Proposal for 6G SAS Rx Converged Tolerance Test

Mike Jenkins
LSI Corp.

Figure 131 — Stressed receiver sensitivity test block diagram

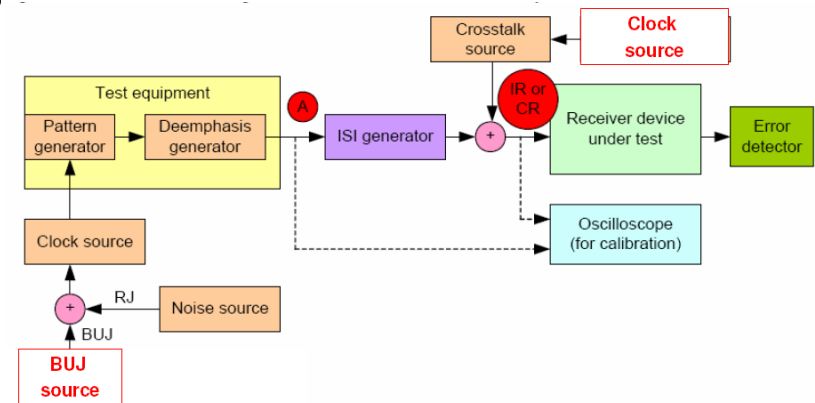
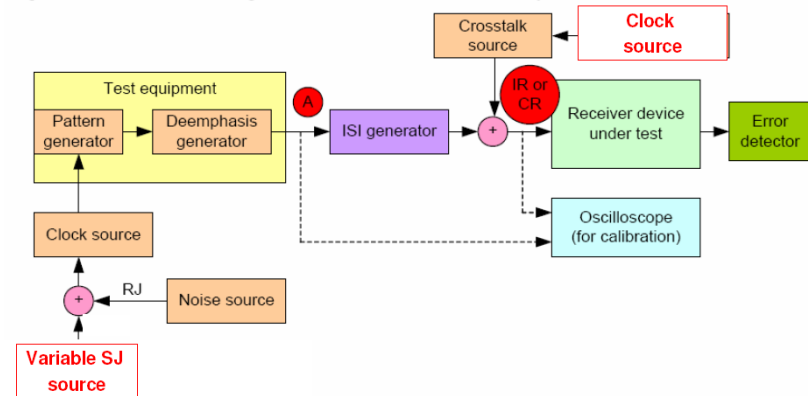
- Only difference is BUJ vs. SJ...but SJ is BUJ
- Stress non-SSC compliant RX with "standard" profile
- Stress SSC compliant RX with "inverse JTF" profile

- Combine Stressed RX & Jitter Tolerance tests into one test with BUJ represented by a frequency profile of SJ
- To verify RX SSC tolerance, the SJ profile can be modified to track the inverse of the JTF

Figure 122 — Applied sinusoidal jitter

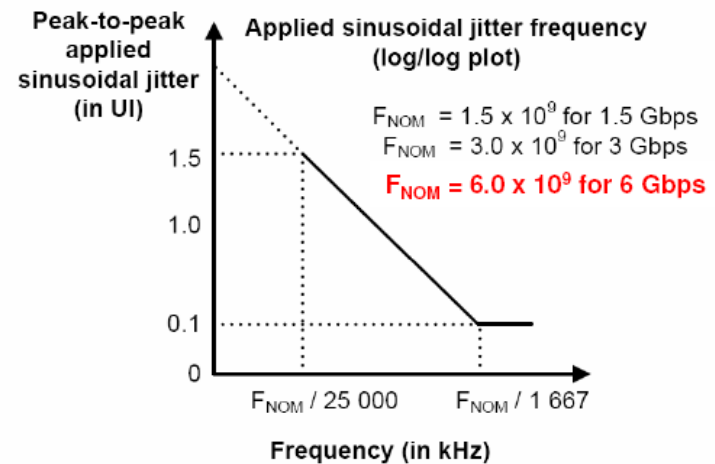
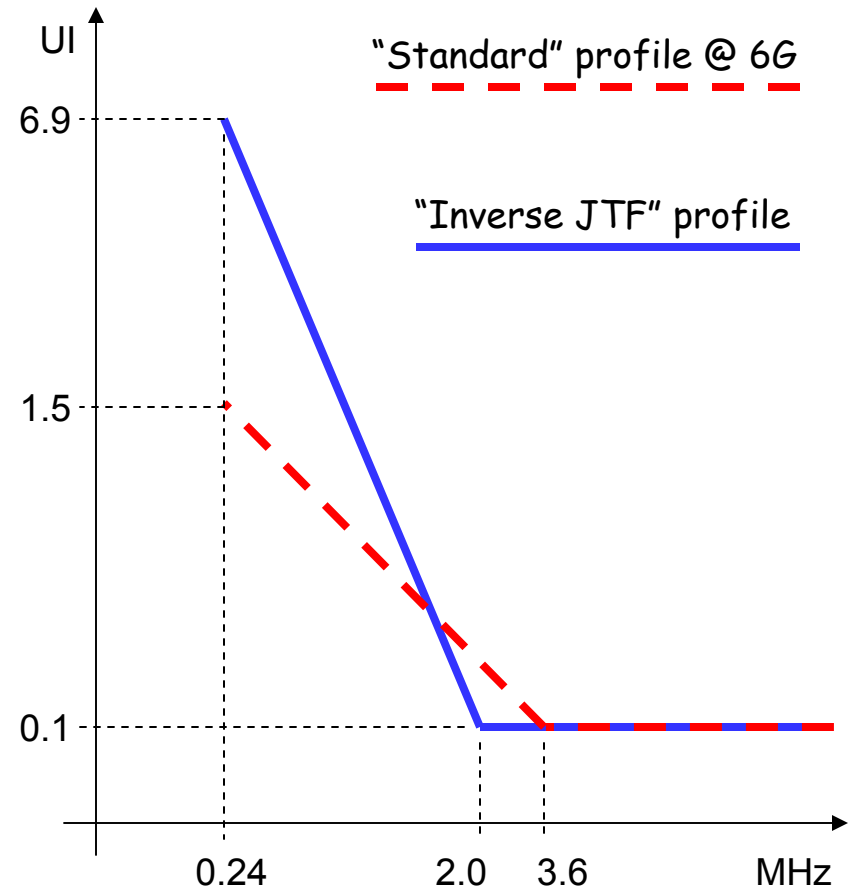
- This profile is inconsistent with TX jitter tests using JTF
 - Does not guarantee tolerance at lower frequencies

- Problem(?): Lab equipment SJ phase modulation limited to $\sim 8UI$
- This limits low frequency end of profile to $\sim 8x$ higher than SSC fundamental
